December 18, 2020

Subject: NRC Review of NEI White Paper, "Changes to NEI 10-04 and NEI 13-10 Guidance for Identifying and Protecting Digital Assets Associated with Security," Dated December 2020

Project Number: 689

Figure 1 - Access Authorization UAA/UA Process

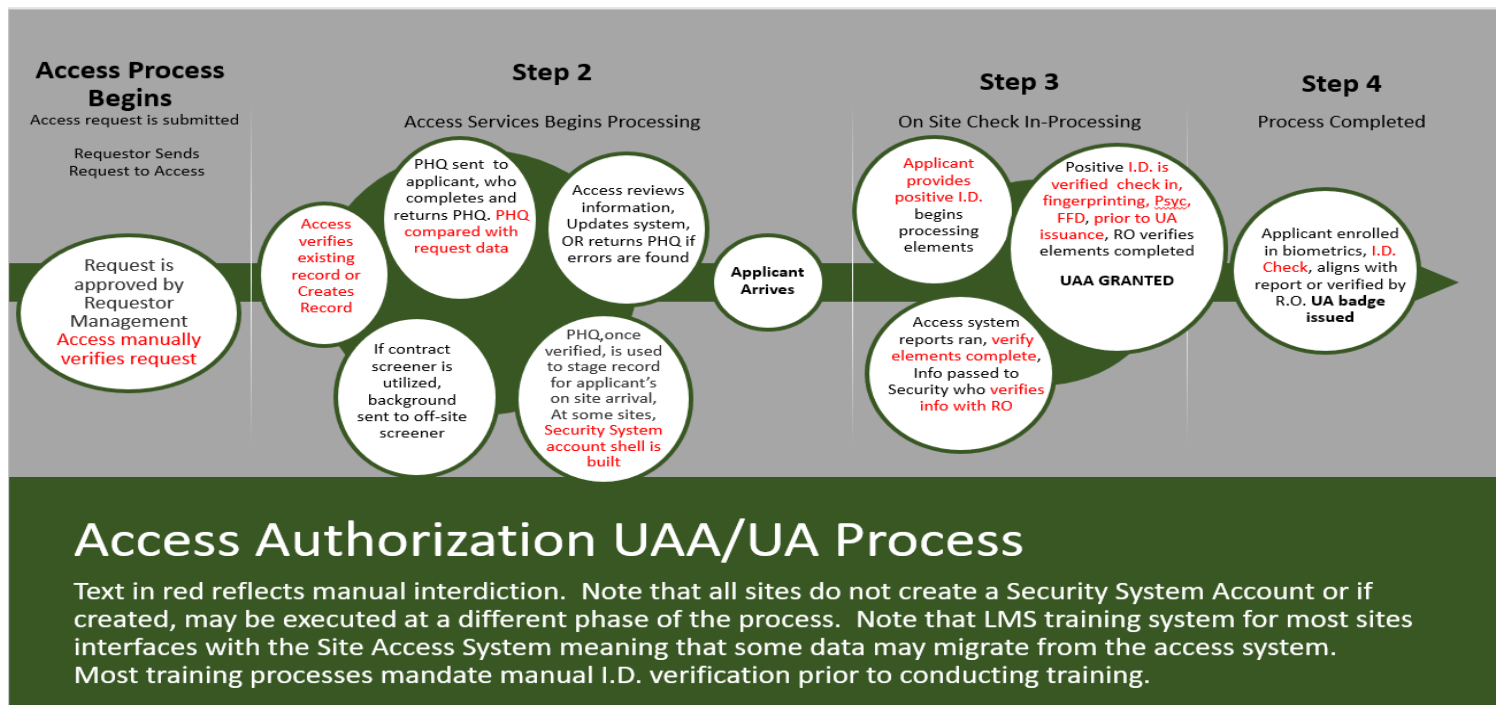
Licensees may use a combination of printed records along with existing digital assets on their corporate network to store and transmit AA data. In these situations, the 10 CFR 73.54 analysis would determine the AA digital assets are not CDAs. The manual data verification steps in the process precludes compromised digital asset data from being entered into the Plant Security Computer System (PSCS). Verification should be addressed in a timely manner to ensure records are not altered between the time verification takes place and when the individual's access is processed. While the AA digital assets are not classified as CDAs, licensees should document in their analysis how the 10 CFR 73.56(m) and 10 CFR 73.56(o) requirements are being addressed. Figure 1 documents a typical Access Authorization UAA/UA process workflow:

The red-colored text in Figure 1 document steps in the process that require manual verification to ensure data integrity. Listed below are three (3) acceptable methods that can be used to implement the Figure 1 manual data integrity verification steps.

Example #1 (Manual Method)

- Request for access is submitted, the request becomes a source document.
- A Personal History Questionnaire (PHQ) is sent to the applicant, who returns the PHQ to the utility.
- The PHQ is verified to match the request data.
- Positive identification during the completion of elements. UAA granted after validating completion of elements in source file.
- Positive identification prior to badging.
- Badge data sent to Security.
- Security validates information with Reviewing Official prior to activating UA.
- UA information validation requires concurrence prior to activation in Physical Security Computer System.

Example #2 (Manual and Digital)

- Request for access is submitted, the request becomes a source document.
- A PHQ is sent to the applicant, who returns the PHQ to the utility.
- The PHQ is verified to match the request data.
- Positive identification during the completion of elements. UAA granted after validating completion of elements in source file.
- Positive identification prior to badging.
- Badge data verified against previously provided digital records.
- Security validates information with Reviewing Official prior to activating UA.
- UA information validation requires concurrence prior to activation in Physical Security Computer System.

Example #3 (Digital)

- Request for access is submitted, the request data becomes the source document.
- A PHQ is provided to the applicant, who returns the PHQ to the utility.
- The PHQ is verified to match the request data.
- Positive identification during the completion of elements. UAA granted after validating completion of elements in source file.
- Positive identification prior to badging.
- Access or Security personnel verify badge data against source documents.
- UA information validation requires concurrence prior to activation in Physical Security Computer System.
